**AIP 3-22-0006-128-2023 & H.015713**  
**TAXIWAY LIMA EXTENSION AND DECOMMISSIONING OF GA RUNWAY 4R-22L AND TAXIWAY ECHO**  
BATON ROUGE METROPOLITAN AIRPORT

**ADDENDUM NO. 1**

**DATE ISSUED: JULY 18, 2024**

1	REVISED PER ADDENDUM NO. 1	DLH	KWP	KWP	07/18/2024
NO.	REVISIONS	DSGN	CHKD	APVD	DATE

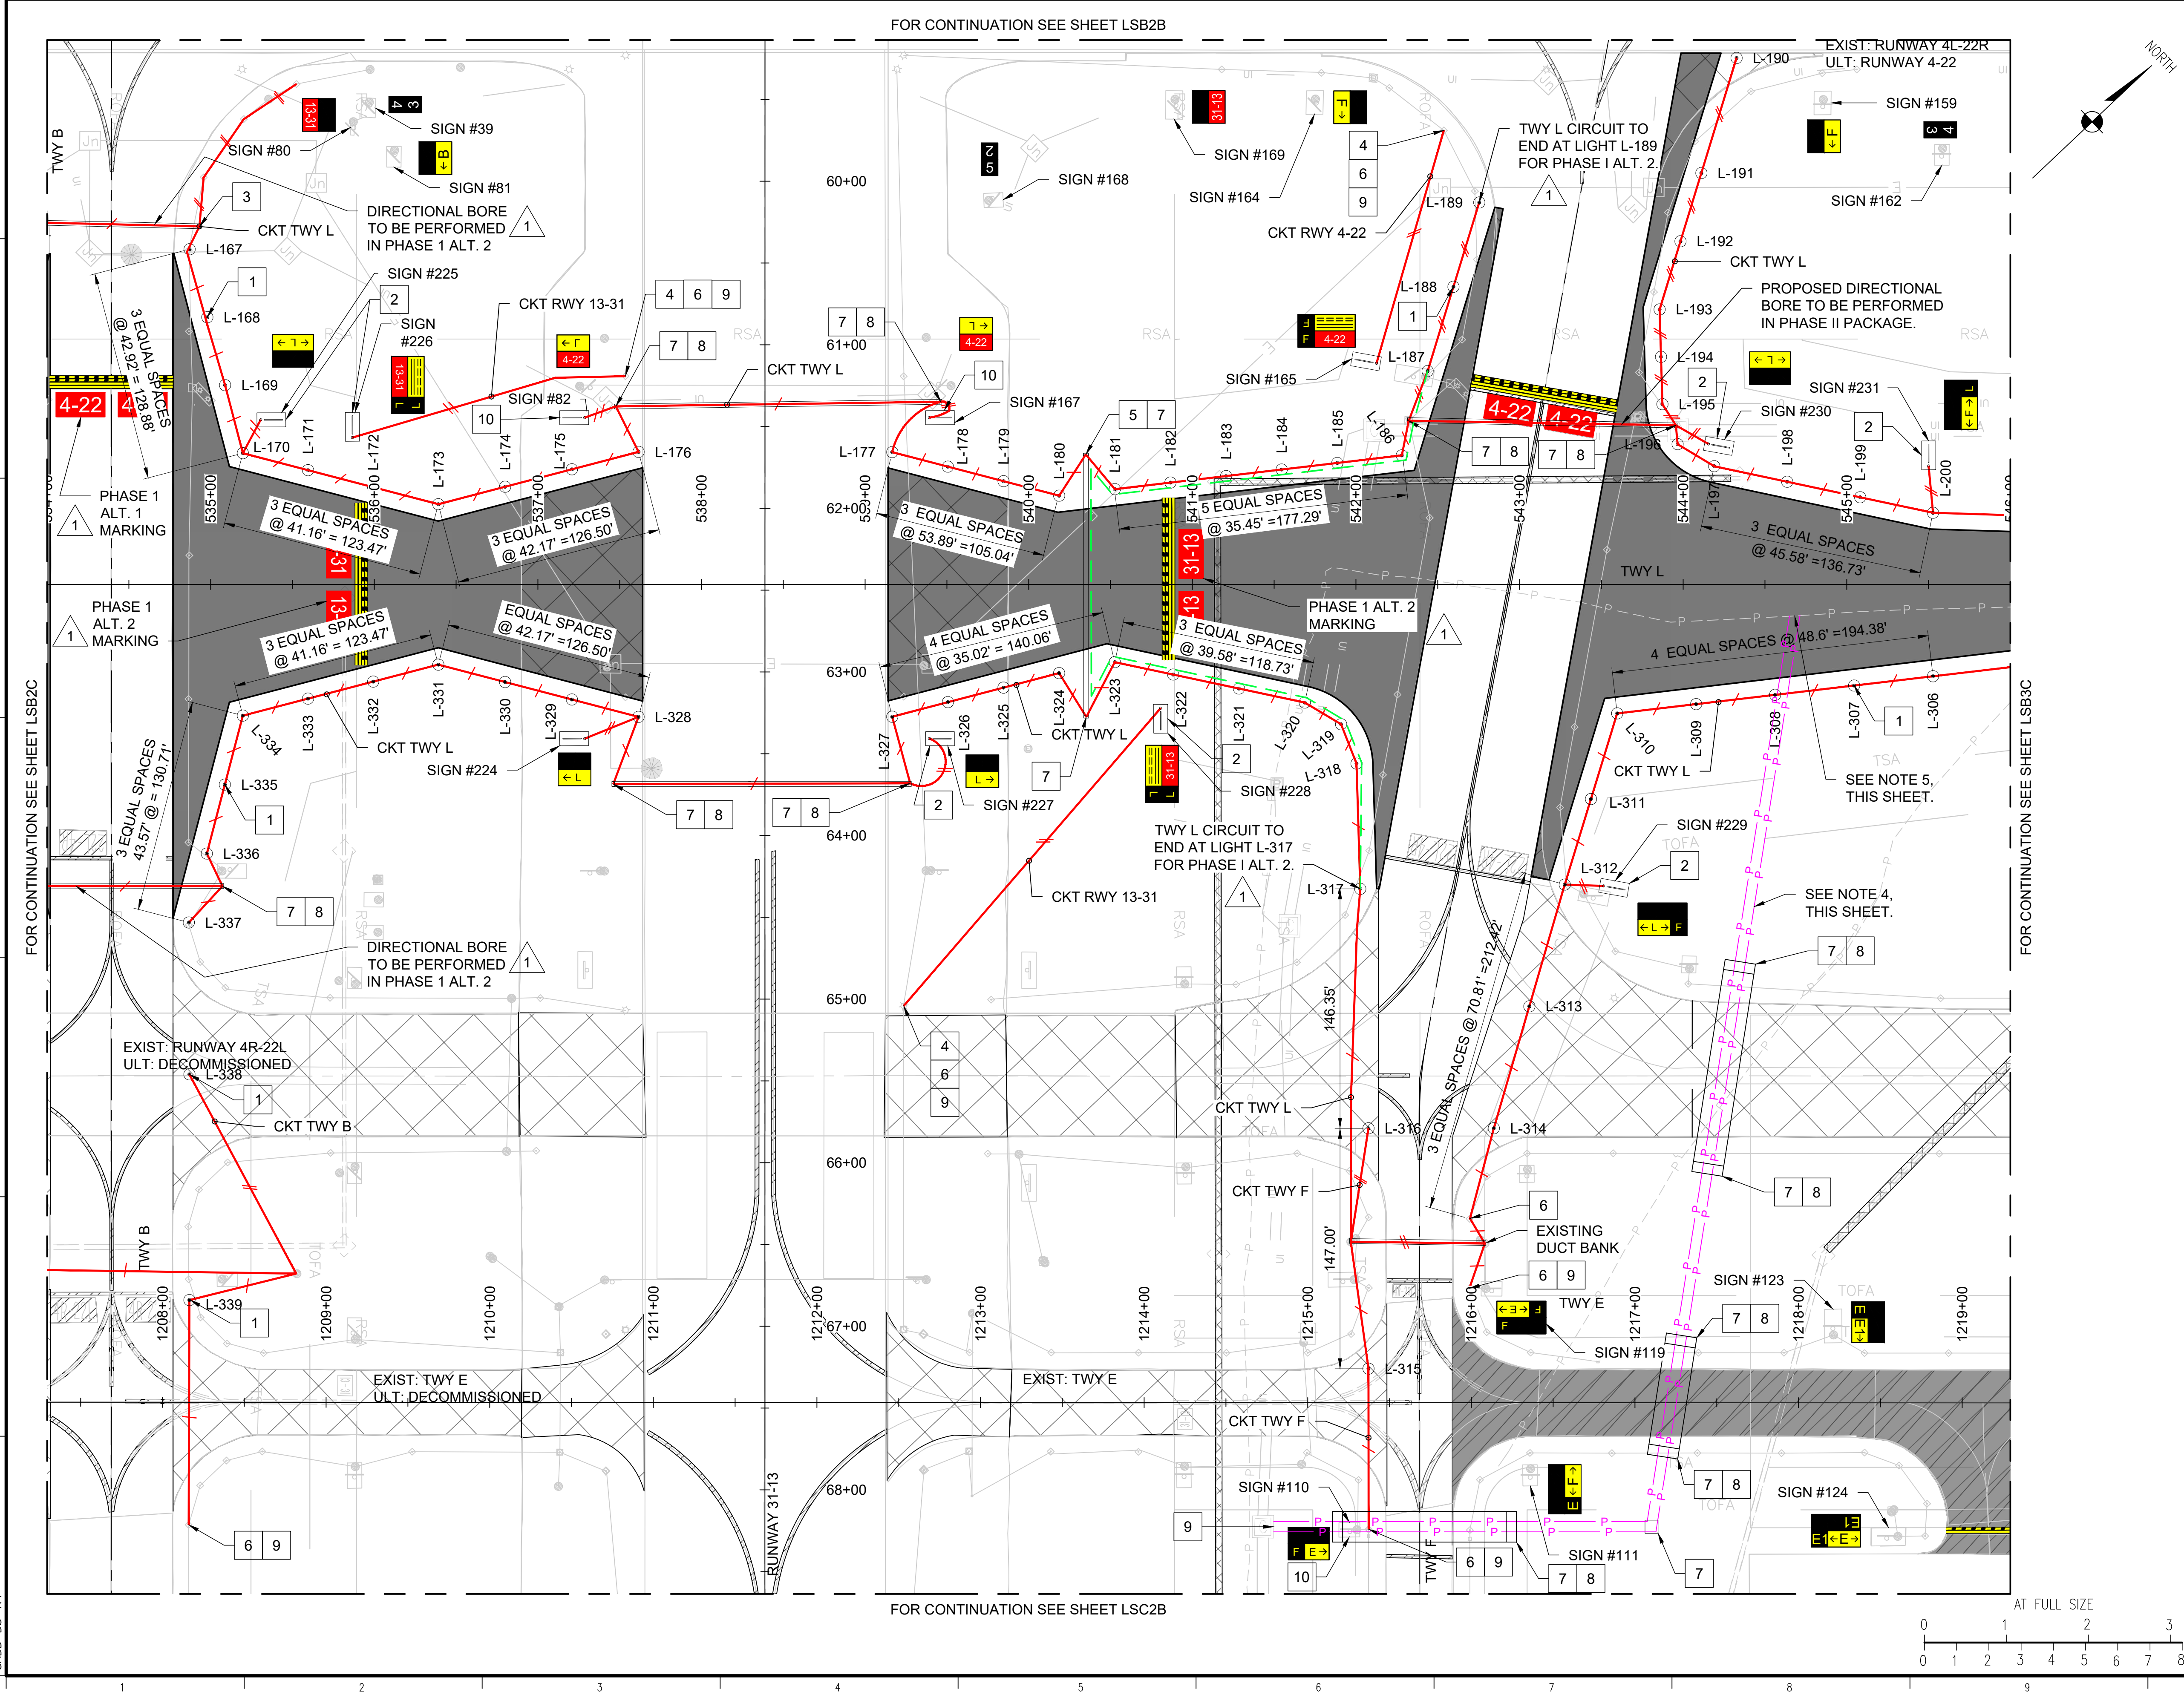
- SEE SHEET LS200 FOR NOTES.
- ALL SIGNAGE AND LIGHTING WORK EAST OF TAXIWAY F IS PHASE II. NOT IN CONTRACT.
- PHASE I CIRCUIT CONSTRUCTION WILL CONCLUDE ON THE SOUTHWEST SIDE OF TWY F. A TEMPORARY INTERCONNECTION CIRCUIT WILL BE INSTALLED TO LINK THE LOOP FOR CKT TWY L. THIS TEMPORARY INTERCONNECTION WILL ORIGINATE AT LIGHT L-187 AND EXTEND TO LIGHT L-317 AS INDICATED IN THE PLAN VIEW. UPON COMPLETION OF PHASE II CONSTRUCTION, THE TEMPORARY INTERCONNECTION IS TO BE DISCONNECTED.
- REQUIRED 2-2" CONDUITS FOR TEMPORARY COMMUNICATION LINE. PROVIDE 1-12 PAIR CONTROL CABLE PER CONDUIT. INCLUDE 1 REQUIRED #1/0 GUARD WIRE FOLLOWING PARALLEL. GROUND RODS TO BE SPACED 90' O.C.
- REQUIRED RAYCHEM SPLICE KIT TO BE USED FOR TEMPORARY CONNECTION TO EXISTING CIRCUIT.
